DO NOT SCALE DRAWING	SIZE	DWG. NUMBER	REV
() = REFERENCE	D	C SUBMITTAL_BR2B	F

4"-16" BR-STYLE SERVICE SADDLE
BRONZE SERVICE SADDLE
WITH DOUBLE BRONZE STRAPS

SMALL BOSS SADDLE
TAPS 0.50"-1.00"

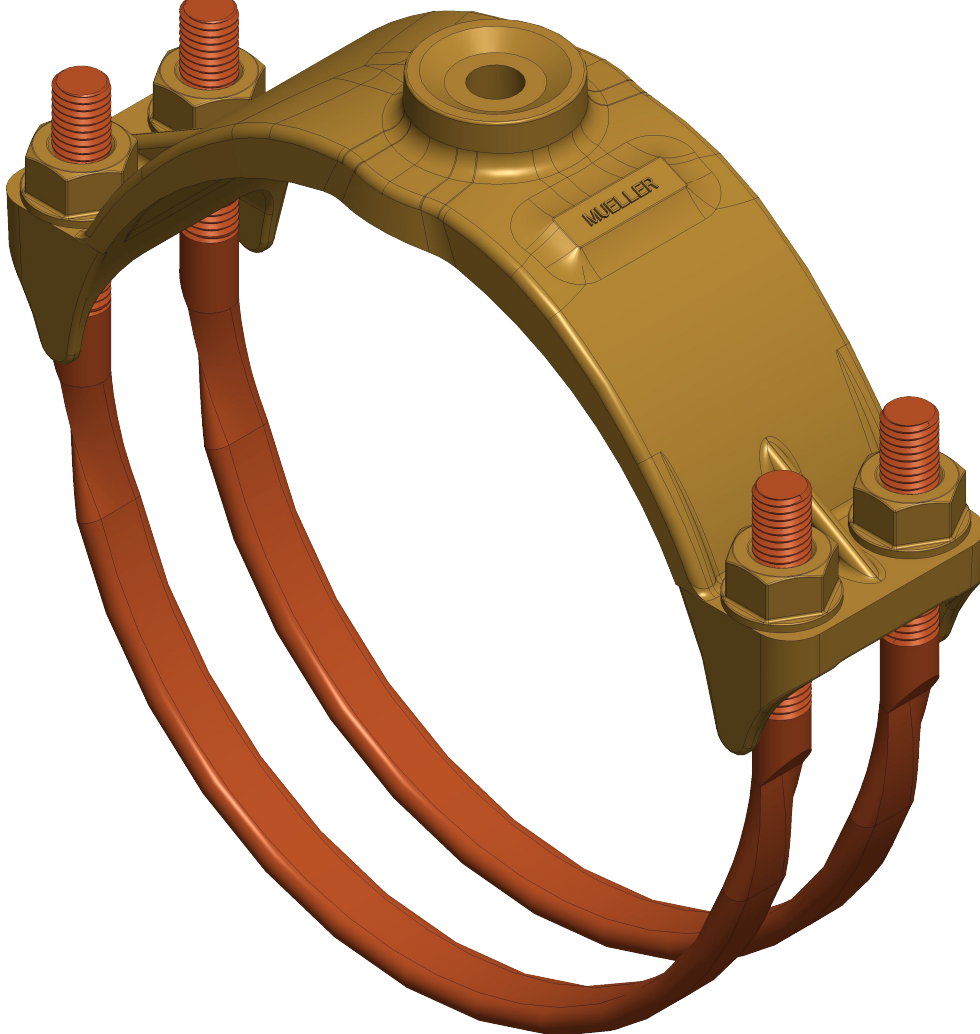
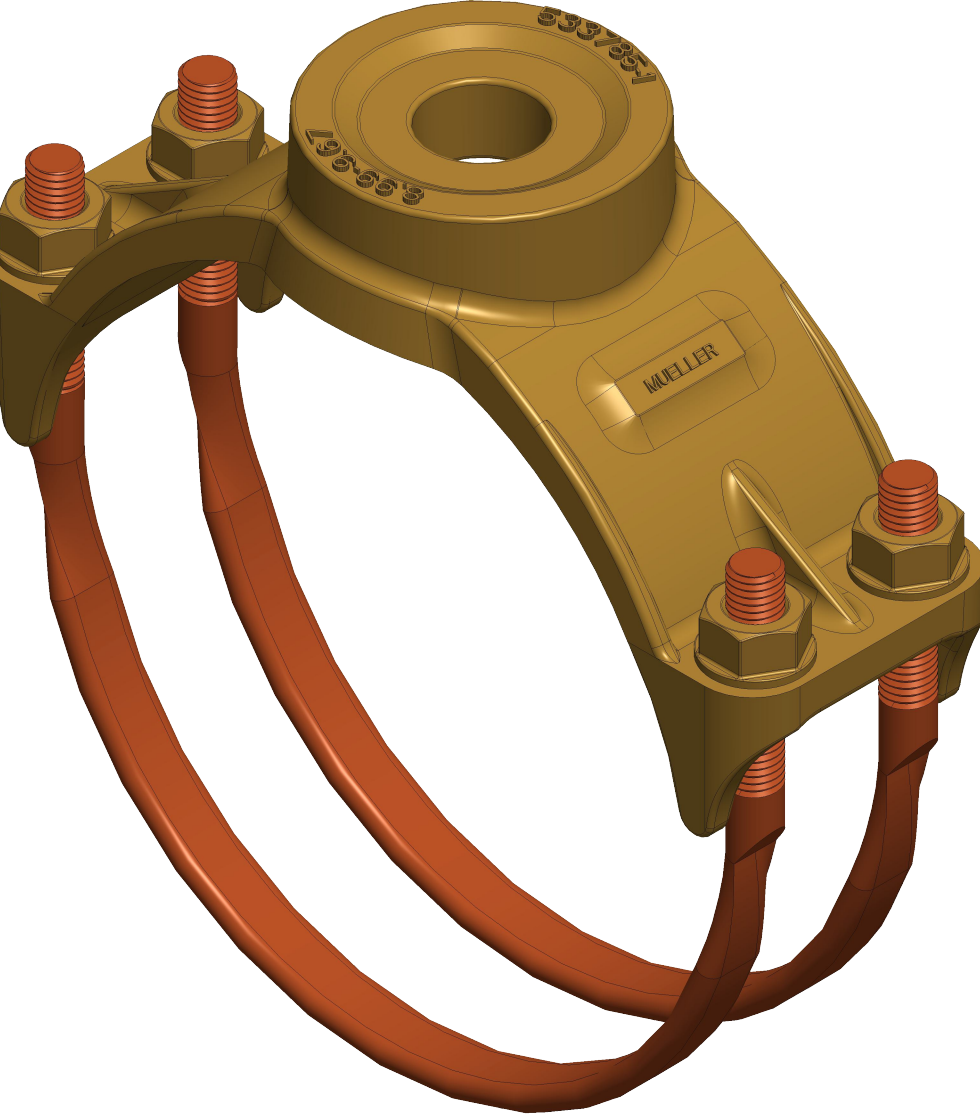
CURRENT DESIGN

UPDATED DESIGN

LARGE BOSS SADDLE
TAPS 1.25"-2.00"

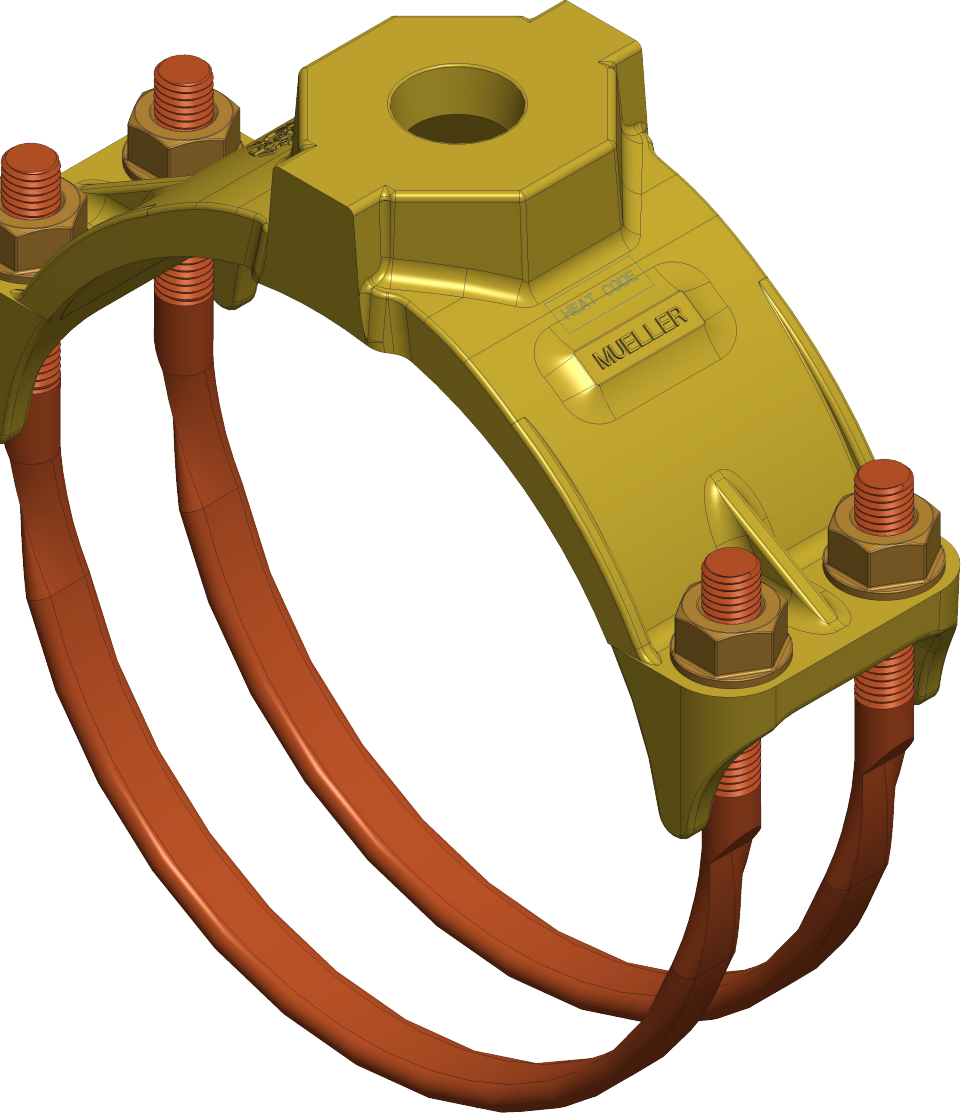
CURRENT DESIGN

UPDATED DESIGN
